SB, 3120XP, Ignition system 2001-01

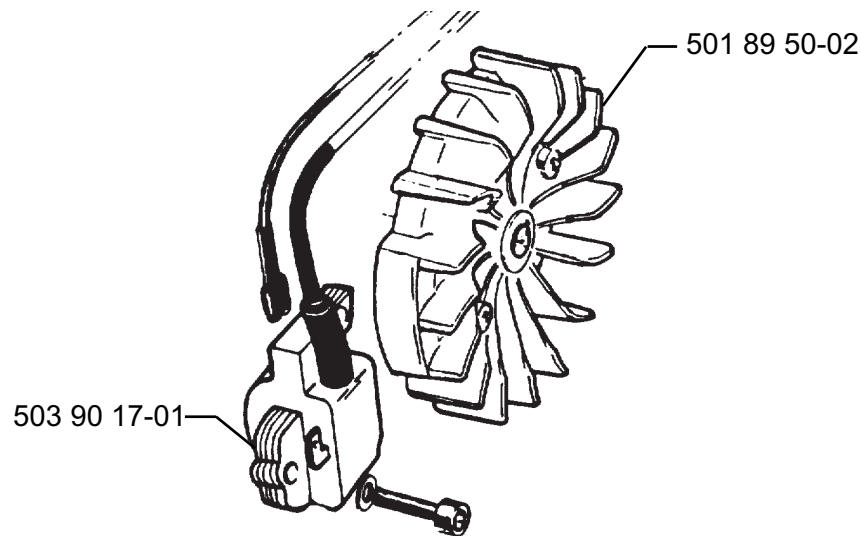
An ignition system with a speed limitation of maximum 9,750 +/- 250 rpm will be fitted to variants 965 96 00-06 and 965 96 00-07 (USA and Canada). The ignition systems can be distinguished as the latter is coloured green while the earlier is black.

This also means that a flywheel with another ignition timing is fitted.

Note! None of these parts can be combined with previous designs.
